PROJECT:
P500 House Type 2

DESCRIPTION:
House Type 2 - Proposed Plans 01

PURPOSE OF ISSUE:
Planning

FILE IDENTIFIER:
LR-BTP-01-ZZ-DR-A-3788_156.C

House Type 2 - 3BH 96m² Ground Floor Plan
1 : 50

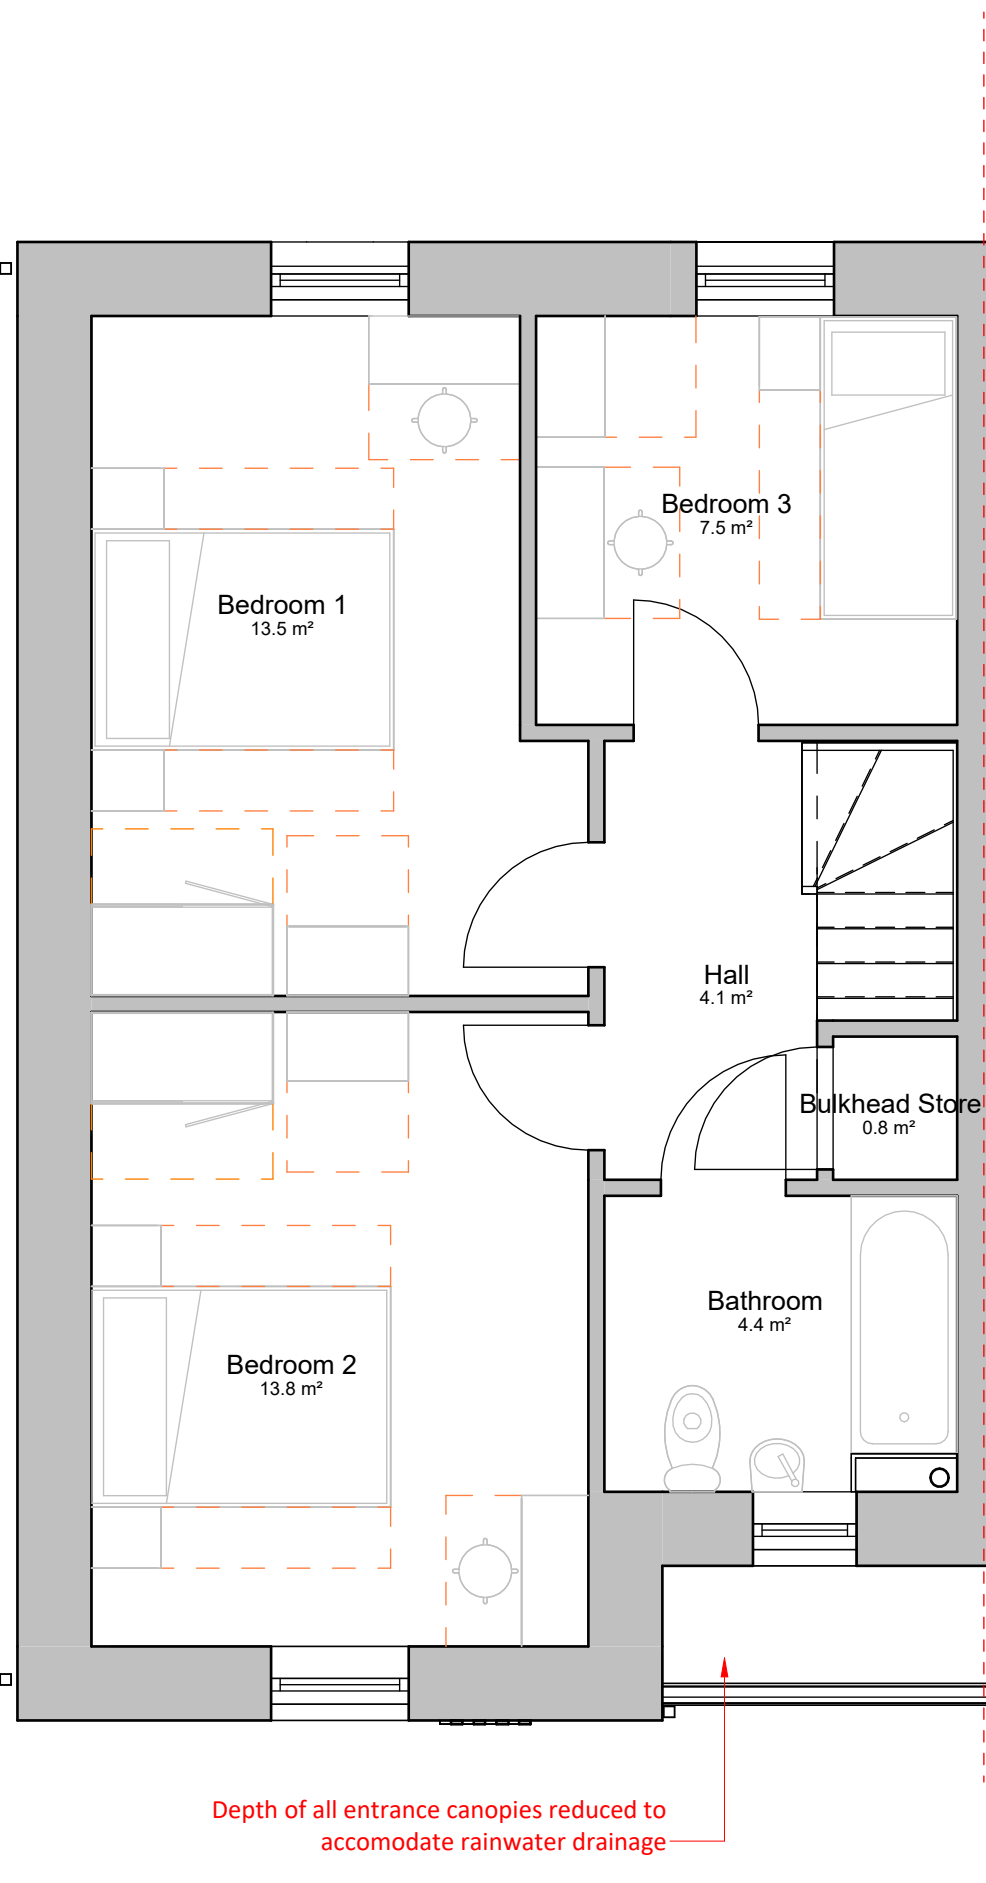
*Internal layouts updated to accommodate cylinder store.
1no. meter box to front of each unit removed in accordance with proposed installation of ASHP and MHVP system
